ADDENDUM NO. 1

**Re: ITB# 3083-18: EWRF Lift Station Relocation and Reaeration Blower
Replacement**

EASTSIDE WATER RECLAMATION FACILITY
REAERATION BLOWER REPLACEMENT PROJECT

PIPE TRENCH DETAIL

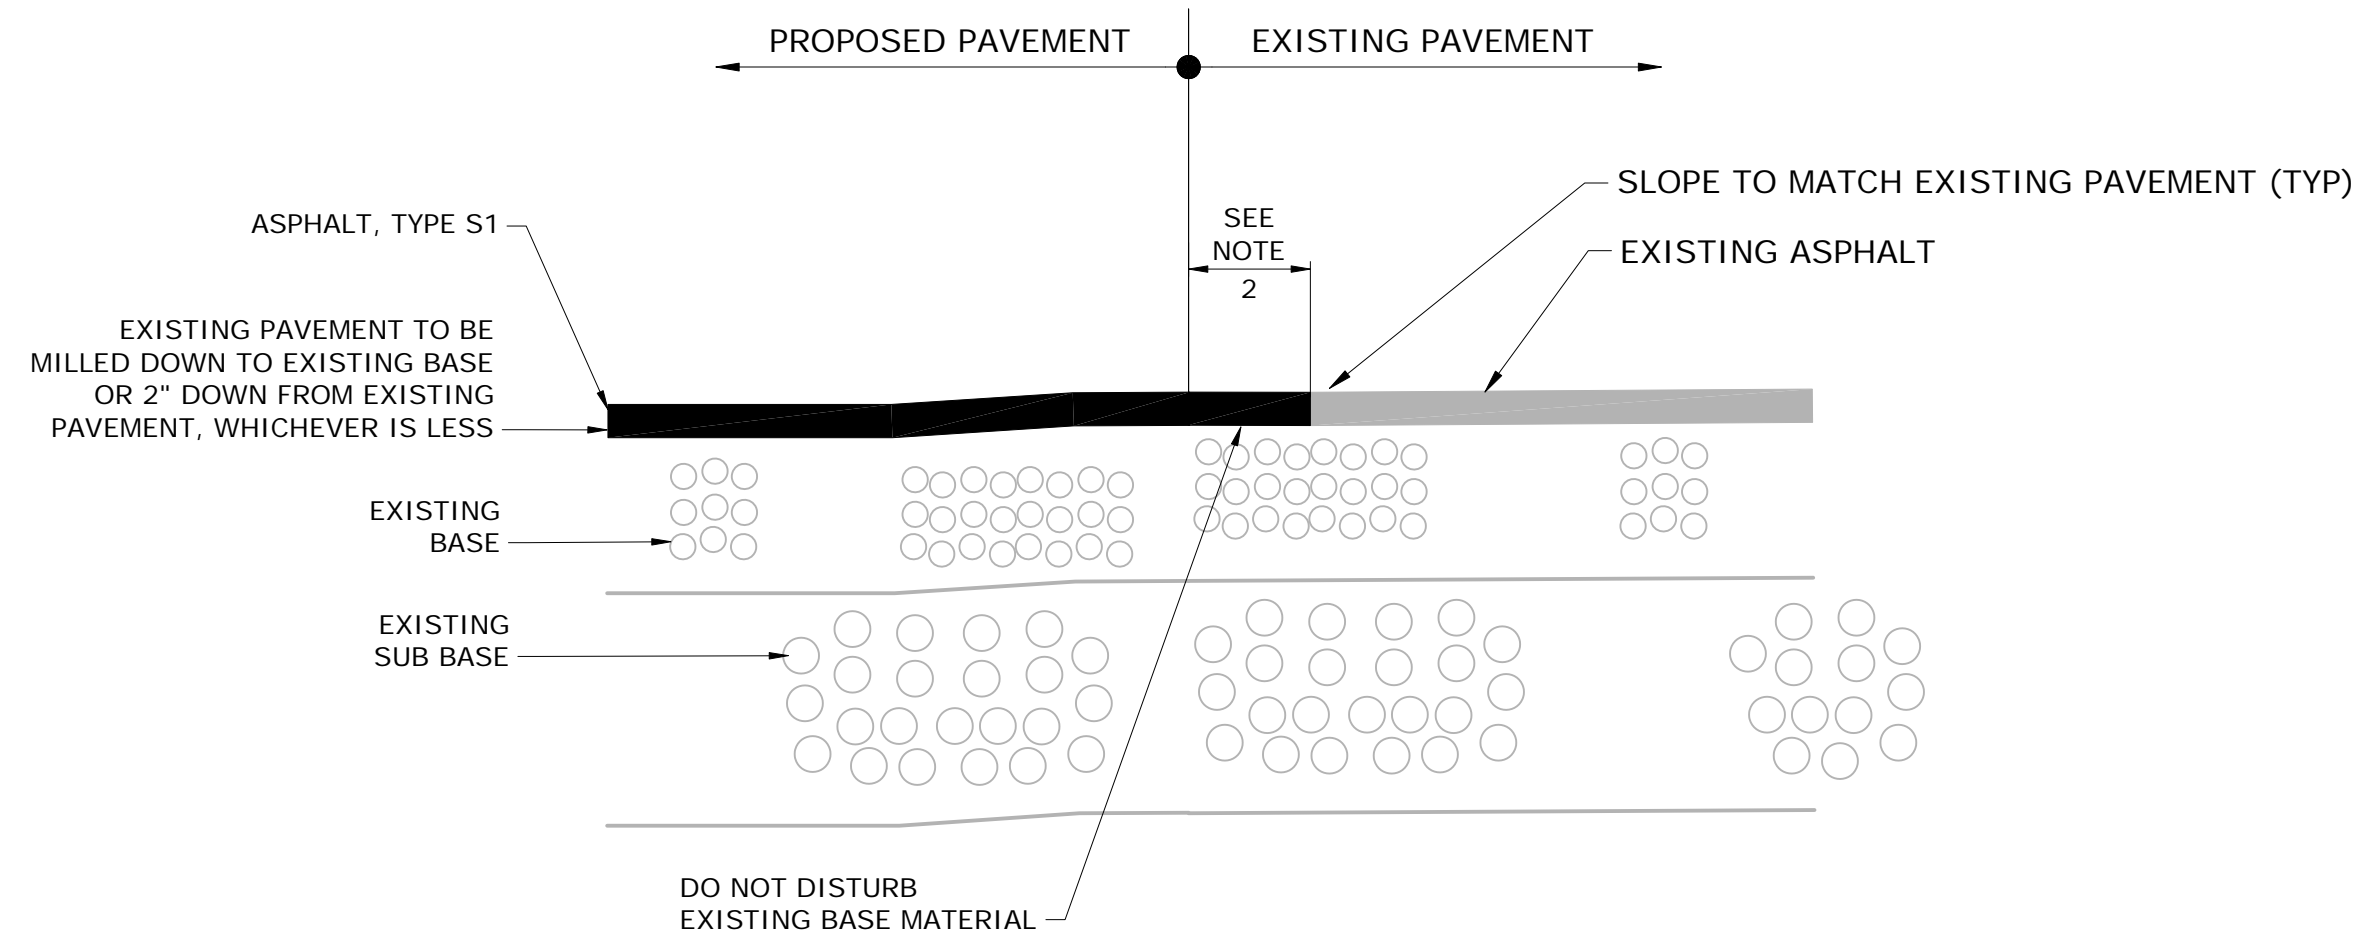
- Issue updated sheet C05, with modifications to pipe bedding detail (attached).
- Modify Section 02222, Excavation and Backfill for Utilities, paragraph 3.05.A to read as follows:

Pipe trenches shall be excavated as described in Article 3.01 of this Section. The resulting excavation shall be backfilled with acceptable pipe bedding material, ~~up to the level of the centerline of the proposed pipe barrel~~ to 6-inches above the top of pipe. This backfill shall be tamped and compacted to provide a proper bedding for the pipe and shall then be shaped to receive the pipe. Bedding shall be provided under the branch of all fittings to furnish adequate support and bearing under the fitting.
